Final decision

**ElectraNet  
transmission determination  
2008–09 to 2012–13**

11 April 2008

**Figure A.1: Contingent risk annual dollar consequence sensitivity test results**

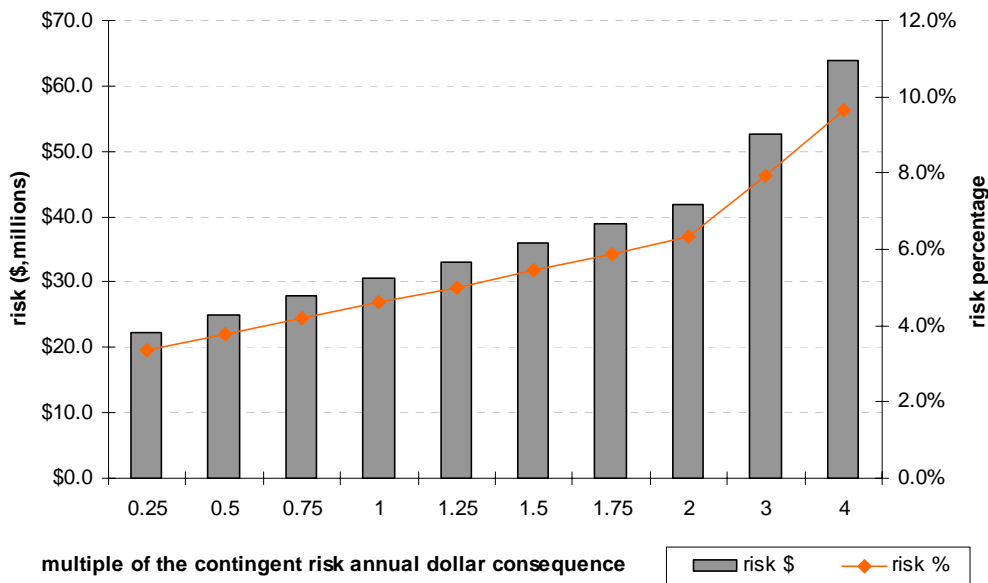
In contrast, the Adelaide CBD and contingent risks categories were based around dollar consequences and a corresponding likelihood of occurrence (risk profile) for the identified risk elements. These values and risk profiles were determined at the risk workshop. Unlike the base cost estimates in the inherent risk category, the dollar consequences and likelihood of occurrences used in the Adelaide CBD and contingent risks categories are not based on comparable actual past outcomes. The AER considers that corporate knowledge, per se, whereby these annual dollar consequences and likelihood of occurrences are developed without any evidence of independently verifiable past experiences, does not lend itself to achieving the stated outcome of providing efficient allowances for costs that are likely to be incurred.

This is even more the case because the AER analysis indicated that the risk model is sensitive to the annual dollar value consequence assigned to each contingent risk element. Holding everything else constant, changing the annual dollar consequence for each contingent risk element (multiplying by various values to adjust the dollar consequences) resulted in significant changes to the overall risk factor, as shown in figure A.1. To be accepted as reasonable inputs to the model, these dollar consequences need to be verified. In the absence of this verification, the AER is not satisfied that ElectraNet has addressed concerns that the risk profiles are not based on past evidence of actual occurrences or actual cost impacts of the identified risk elements.

Although the inputs to the inherent risk category appear to display some moderating influences, given the weight of the other two risk categories (as shown in table A.1) and the sensitivity of the annual dollar consequences (as shown in figure A.1), the AER is not satisfied that ElectraNet has sufficiently demonstrated that the proposed risk factor has accounted for new initiatives and estimating procedures.

**Figure A.2: Results of removing risk categories**

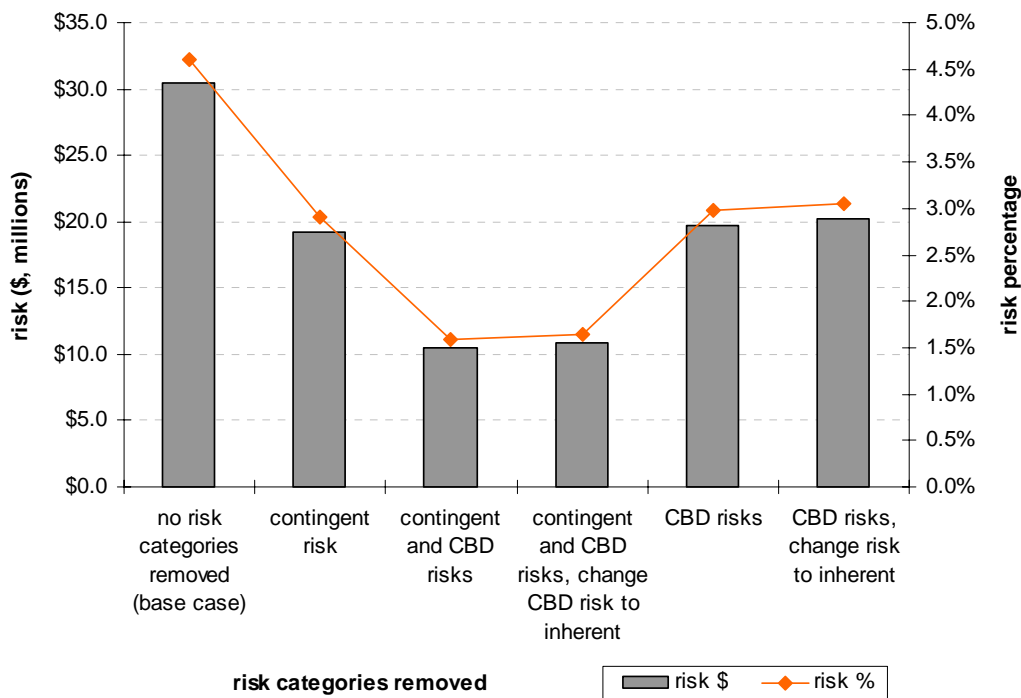
Figure A.2 shows that there is a significant change to the overall risk factor depending on the mix of risk categories used. For example, calculating the Adelaide CBD project risks using the inherent risk methodology rather than as a separate risk assessment causes the overall risk factor to drop to 3 per cent. The AER notes that EP's testing also showed a risk factor of only 2.9 per cent after removal of the contingent risk category.<sup>243</sup>

EP noted that the maximum value of the P50 risk factor recorded in its sensitivity analysis was 8.0 per cent based on doubling the maximum value of the inherent risks.<sup>244</sup> The AER confirms that this test results in a risk factor consistent with EP’s findings. However, in order to derive a clearer picture of the model’s sensitivity to the risk profiles, the AER as well as doubling the inherent risk maximum values, also simultaneously doubled the dollar consequences applied to the other two risk categories within the model. This test resulted in an overall risk factor of 11.33 per cent. Therefore, the AER considers that changes to the risk profiles of the three risk categories will significantly impact on the risk adjusted capex estimate, and that, depending on the combination of changes, the overall risk factor will be significantly affected.

In its supplementary report EP concluded that, based on its experience, ElectraNet’s revised 4.6 per cent risk factor is not unreasonable compared to typical risk based outcomes for other projects and that it is at the lower end of its expectations. The AER notes that ElectraNet’s risk model outcomes are sensitive to variations in the risk profiles. Further, as shown in figure A.2 the combination of risk categories adopted in the risk analysis methodology will also affect the proposed risk factor. Given these sensitivities, EP’s proposed range of typical risk based outcomes will need to be normalised to account for underlying applicable factors such as the modelling methodology, regulatory framework, operational environment etc. Therefore, in this instance, based on the available information the AER does not consider it reasonable to place much weight on EP’s range of typical risk based outcomes.
